**AN ANNOTATED ANALYSIS OF LOGIC  
IN THE 1992 REPORT, "THE ORIGIN AND HISTORY  
OF ALTERATION AND CARBONATIZATION OF THE  
YUCCA MOUNTAIN IGNIMBRITES,"  
BY J.S. SZYMANSKI**

**Nuclear Regulatory Commission  
Contract NRC-02-93-005**

**Bret W. Leslie**

**February 1994**

Figure 8-1. Logic diagram of arguments presented in Chapter 8

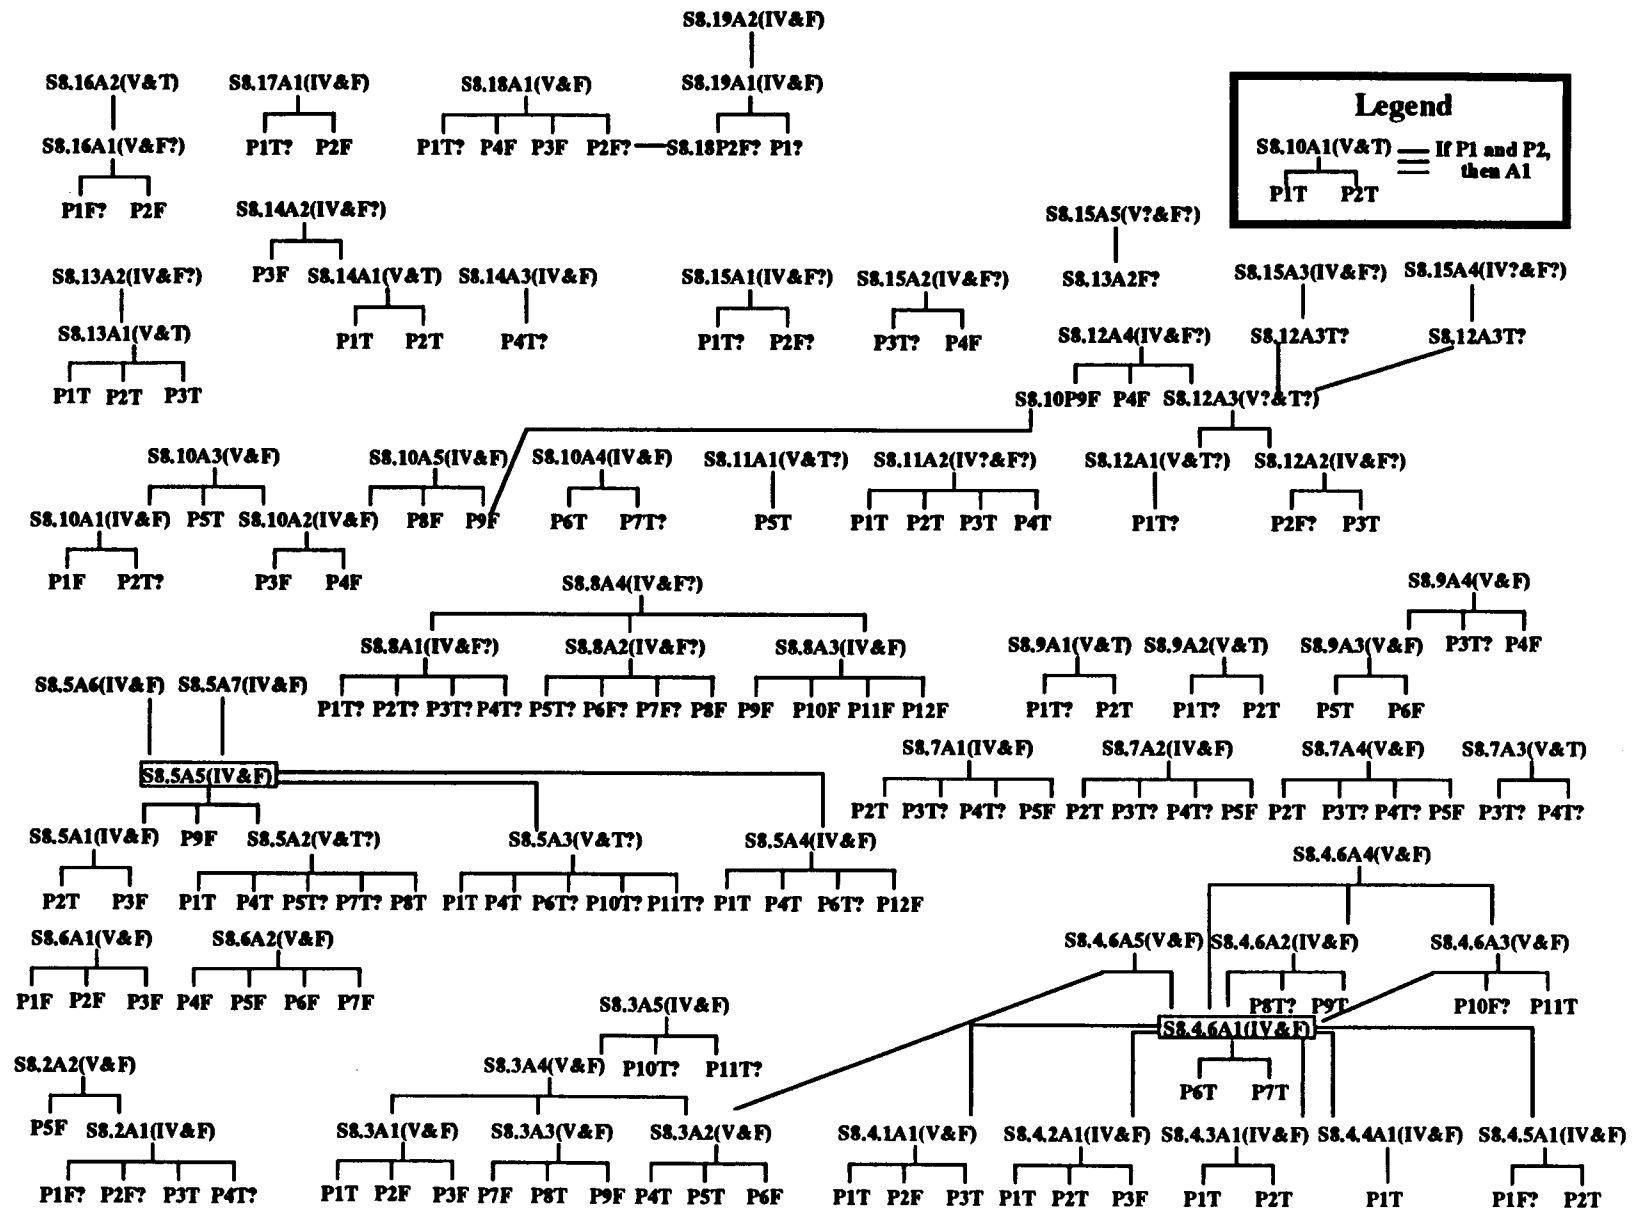
Reviews of the K/Ar dating of volcanic features (Wells et al., 1990; Turrin and Champion, 1991; Crowe et al., 1983, 1986, 1992; Hill et al., 1993) indicate P1 is likely to be false. Szymanski (1992) did not provide a logical connection between the premises and the conclusion of this argument, and A1 is invalid. Since both premises P1 and P2 are false, this suggests the K/Ar and  $^{40}\text{Ar}/^{39}\text{Ar}$  ages for samples of local basaltic flows and cinders are not in fairly satisfactory agreement with average U/Th ages of late epigenetic calcites.

Argument A2 is invalid and the sole premise of this argument is false. Szymanski (1992) did not provide any justification to connect the premise of this argument to its conclusion. The uranium series isotopes presented no substantial evidence to infer a presumed igneous origin of carbon and hypogene origin for the vadose zone and near surface calcites.

**Figure 9-1. Logic diagram of arguments presented in Chapter 9**

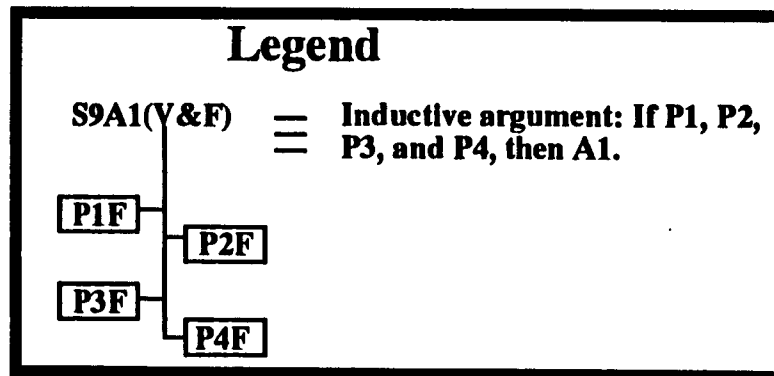
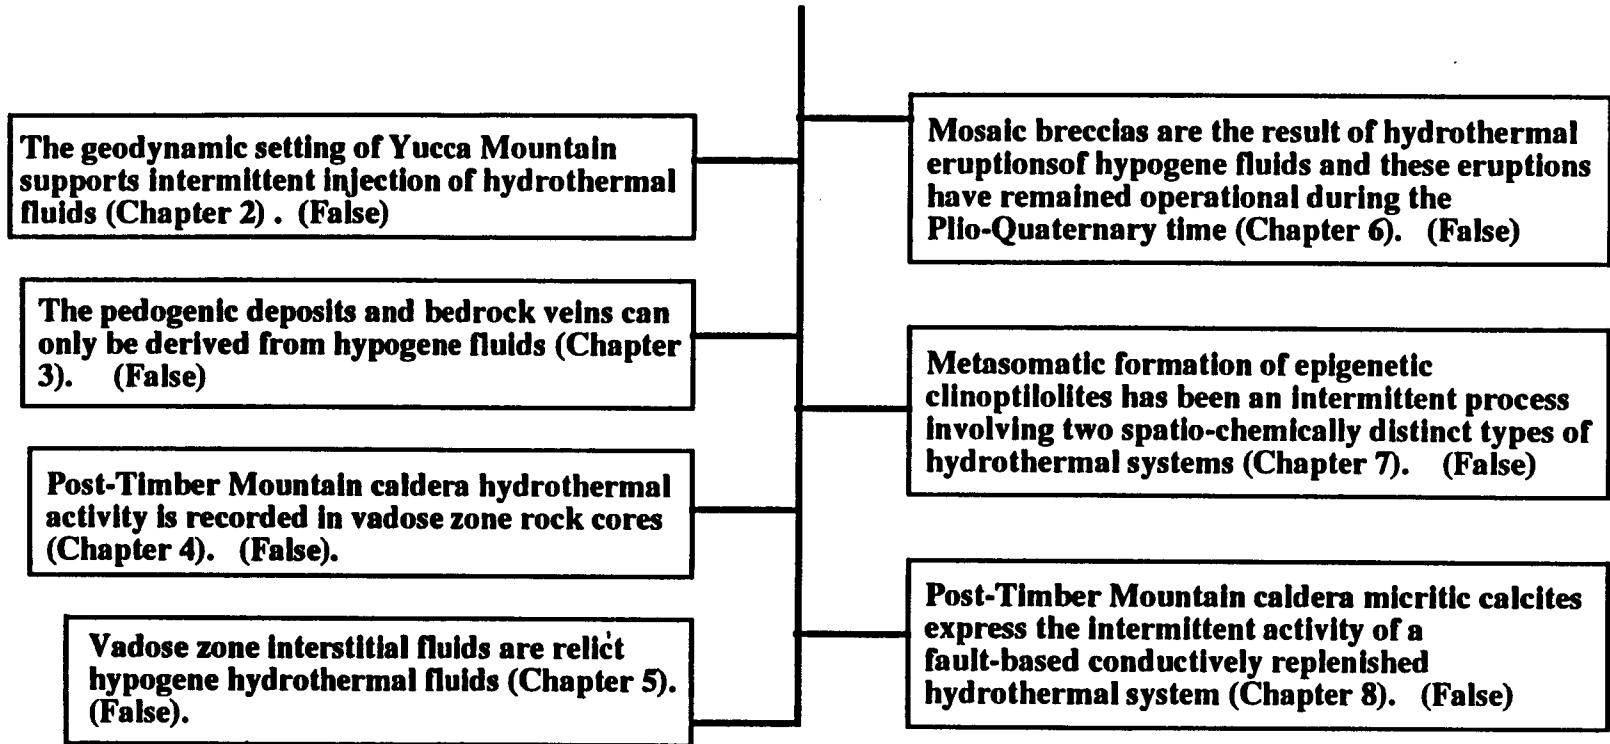
The systematic and comprehensive approach used in this report identified several areas of current scientific uncertainty which directly influence the strength of arguments posed by Szymanski (1992) and which, if resolved, could provide the necessary information to unambiguously conclude between competing premises/models. Technical uncertainties were derived from incomplete characterization of the proposed flux of dust to the topographic surface in the Yucca Mountain area (necessary to support the supergene model), inadequate characterization of the history and mechanisms of recharge to the Alkali Flat/Furnace Creek groundwater system, an incomplete assessment of the degree to which non steady-state processes (climate) may control the formation of pedogenic deposits and other geochemical features of the subsurface, and an insufficient degree of integration of scientific measurements (multiple types of characterization of individual mineral specimens). The critical assumption (Szymanski, 1992) of an asthenospheric mantle as the framework from which geodynamic processes in Yucca Mountain are derived adversely affected many of Szymanski's arguments concerning the geodynamic possibilities for conductive and convective hydrothermal systems in the Yucca Mountain region. Analyses of his geodynamic arguments indicate a clear understanding of the thermal structure of the mantle in the Yucca Mountain area is not available. This seriously impacts the ability to adequately resolve the paleo-geothermal regime. In the future, in order to quickly and accurately examine possible alternative scenarios which could seriously impact the safety of the proposed repository, it would be wise to have the availability of integrated databases.

**Intermittent injection of hypogene fluids into Yucca Mountain is important in a 10,000 year timeframe. (V and F)**
